Comment (#57, #58):
(TDL #513 D2.0).

The following updates to the unbalance requirements are based on the technical principles, 4-pair model and its component values presented Annex D that was used to derive all pair-to-pair unbalance requirements in 802.3bt.

Results:

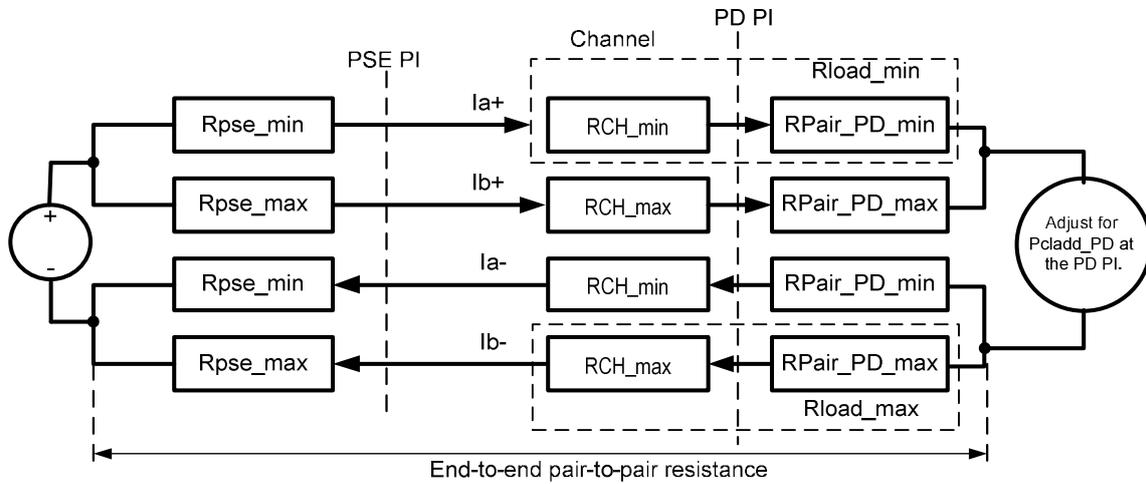
- In simulation, we get accurate results for I_{con-2P_unb} that meets the spec.
- When using single calculation iteration of I_{con-2P_unb} : I_{con-2P_unb} is deviates by +9mA (error=1.31%).
- When using two calculation iterations by subtracting R_{load_min} and R_{load_max} power loss from Ppd, error is reduced and we meet the spec.
- When using two calculation iterations by when breaking R_{load} to R_{ch} and R_{pair_PD} and subtracting R_{pair_PD} loss from Ppd, error is reduced and we meet the spec which prove the point above that for short cable there is need to break the model from 2 parts to 3 parts.
 - The reason for why without breaking R_{load} to R_{ch} and R_{pair_PD} we get the same good results is that at short cable R_{ch} is negligible compare to R_{pair_PD} which is part of the PD.

1. There is no need to calculated $I_{con_2P_unb}$ to meet the spec. The designer need to meet Equation 33-15 only.
2. Equation 33-15 is correct and accurate. No changes are needed.
3. In order to validate that the PSE vendor meets Equation 33-15, he should use Annex 33-B test models as indicated in the spec.
4. For the above use case in short cable, no need to change the model as currently specify in Annex B however it is recommended to do so due to the following:
 - a) It is clearer model that include all necessary information for the designer.
 - b) For long cables, we must break R_{load} to its R_{ch} and R_{pair_PD} components since in this case $R_{ch}>R_{pair_PD}$ which will result with significant error.

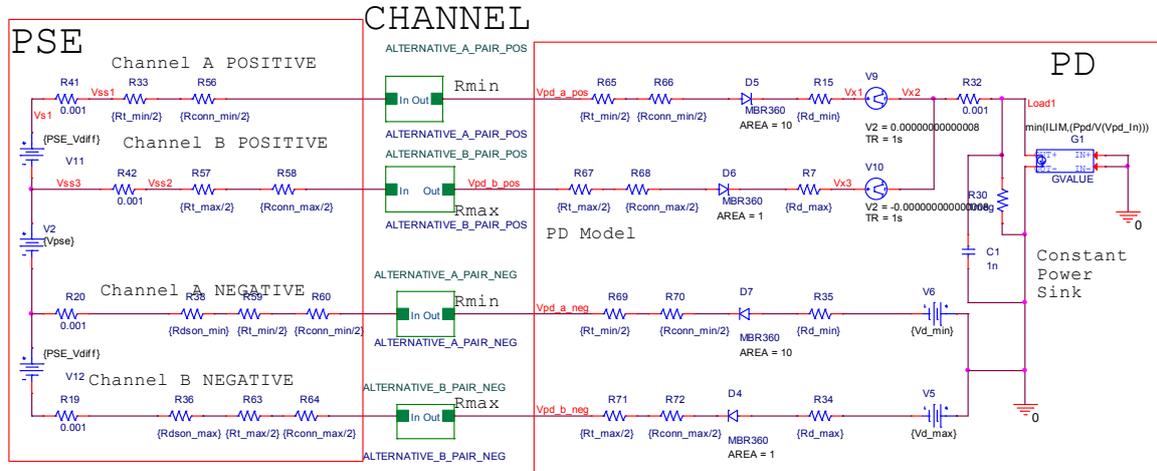
The E2EP2PRunb that was used to derive the U value in Equations 33D-2 and 33D-3 above is found at short cable in order to find the worst case unbalance due to the fact that with long cables the unbalance is improved. Maximum pair current due to E2EP2PRunb is not always obtained at the maximum value of E2EP2PRunb. For Type 3 systems, maximum pair current is obtained at $R_{chan-2P}=0.2\Omega$ (short cable) where E2EP2PRunb is the highest. For Type 4 systems, maximum pair current is obtained at $R_{chan-2P}=12.5\Omega$ (at 100m channel length) where E2EP2PRunb is the lowest.
